Staff Summary Report

Development Review Commission Date: 09/28/10

SUBJECT: Hold a public hearing for two (2) Use Permits and a Development Plan Review for **QUIK TRIP # 1400** located at 2150 East University Drive.

DOCUMENT NAME: DRCr_QuikTrip1400_092810.doc **PLANNED DEVELOPMENT (0406)**

Building Plan

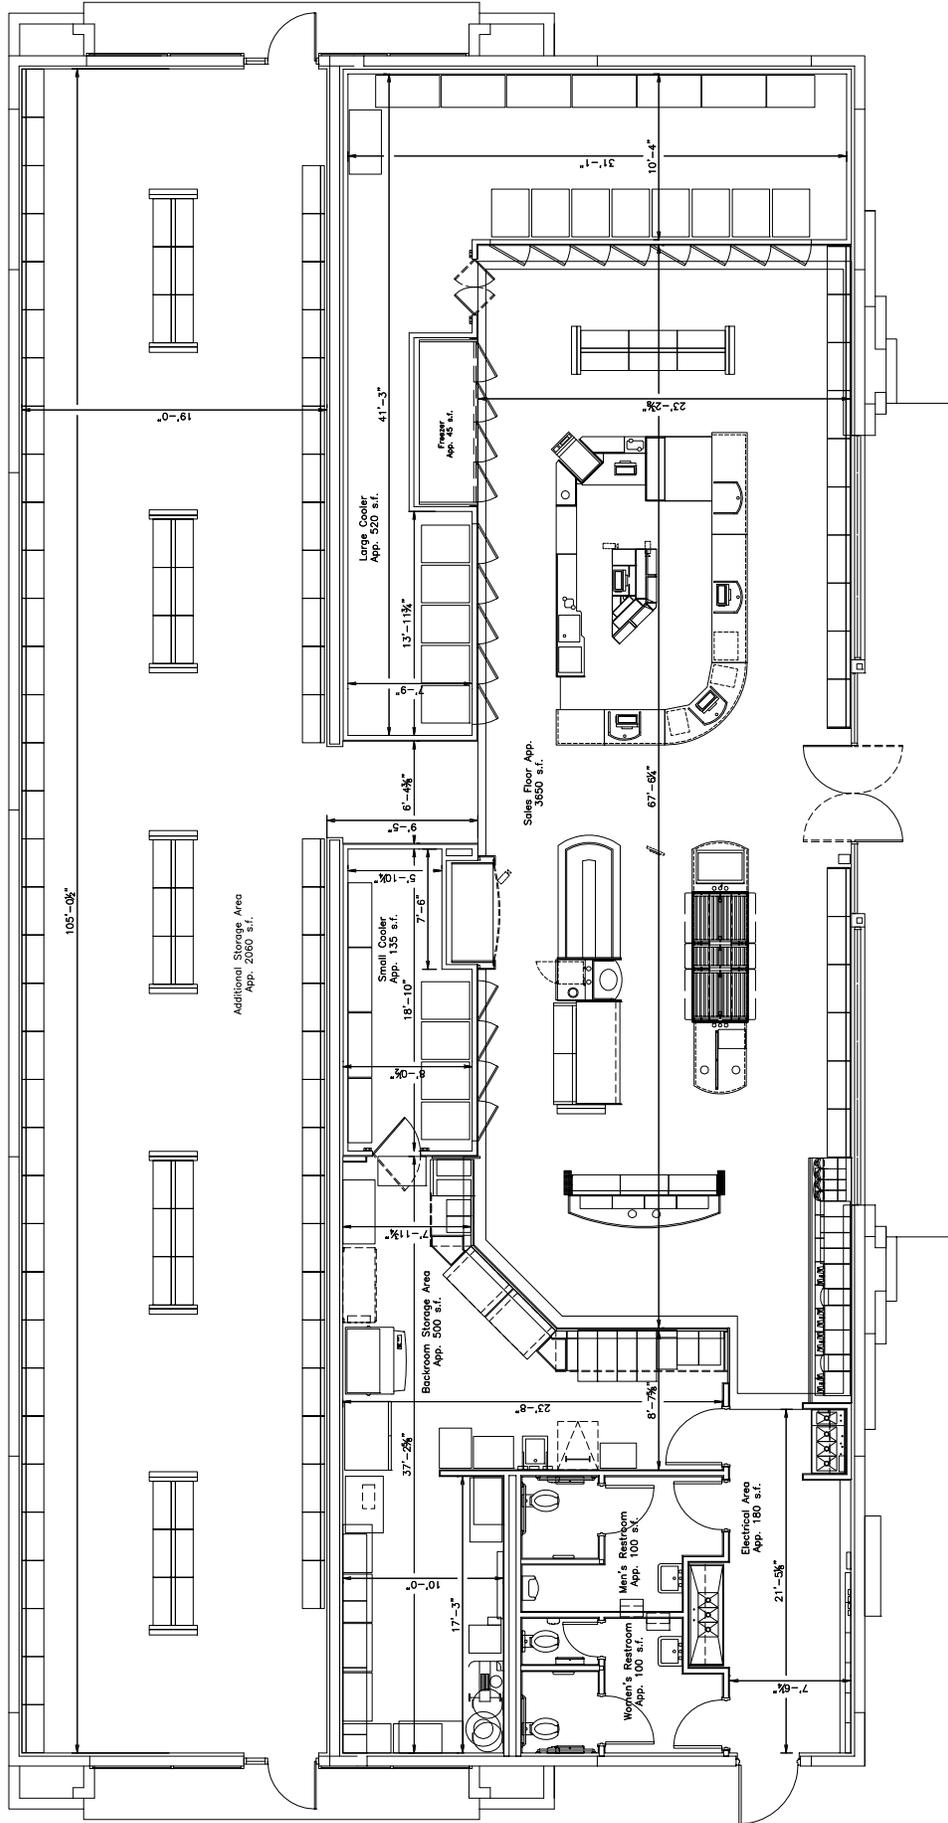
1. Provide a unified convenience store floor plan with a central cashier station that communicates visually with all three store entrances or satisfy the Police Department during the creation of the Security Plan that the store operation allows complete staff coverage of all entrances and store areas during all shifts.

Building Elevations

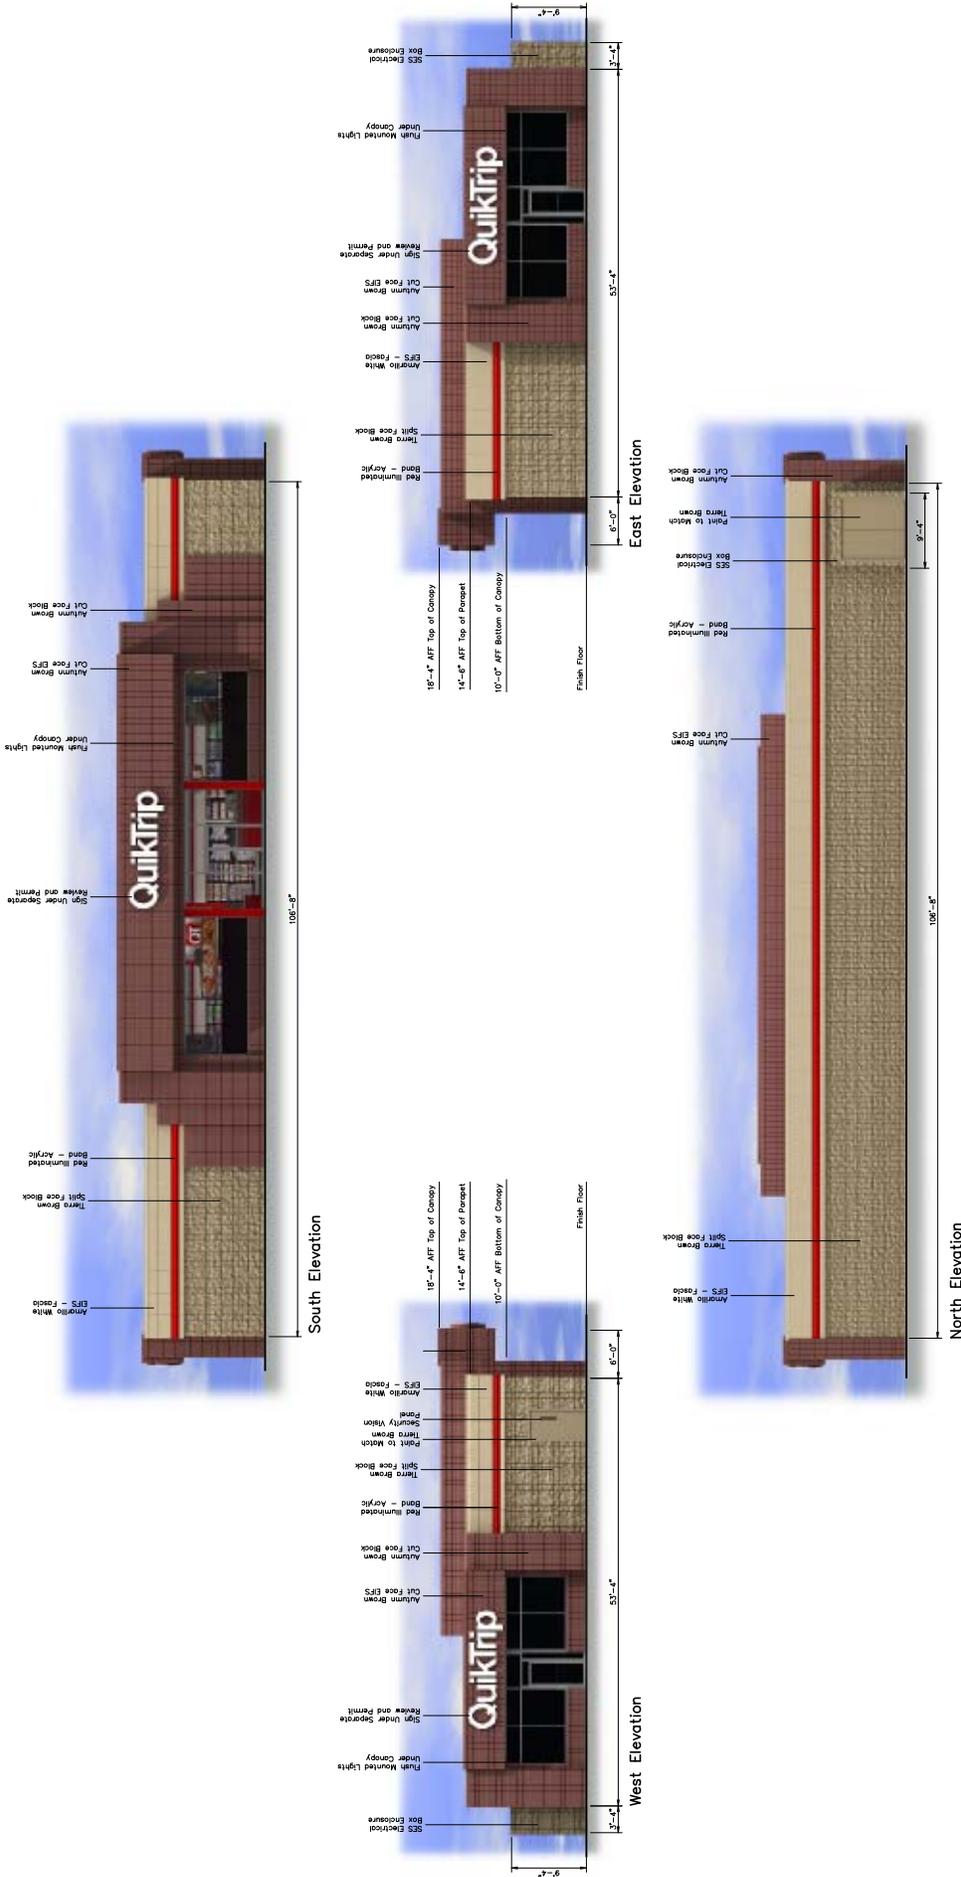
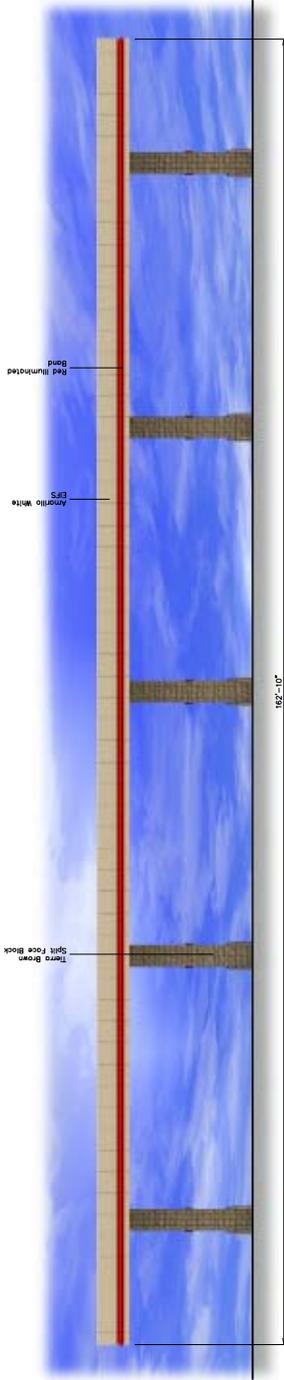
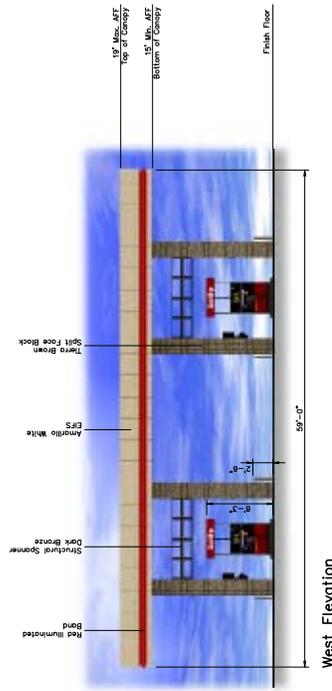
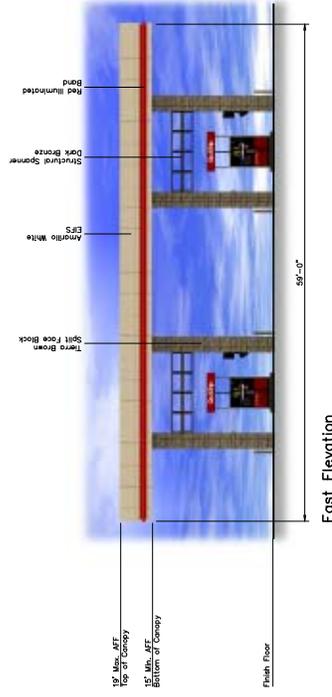
13. Provide glazed storefront with direct visibility into store in addition to glass entrance door at east and west store elevations. Do not provide spandrel glass at these elevations as is indicated on drawing.

15. Provide secure roof access from the interior of the building. Do not expose roof access to public view. Conceal roof drainage system within the interior of the building. Incorporate lighting, address signs, fire department connection and incidental equipment attachments (alarm klaxons, security cameras, etc.) where exposed into the design of the building elevations. Do not locate exposed conduit, piping, or similar features on the exposed surfaces of the building.

16. Concealment of electrical service entrance section inside a masonry enclosure on the north of the store as indicated on the drawing is allowed.
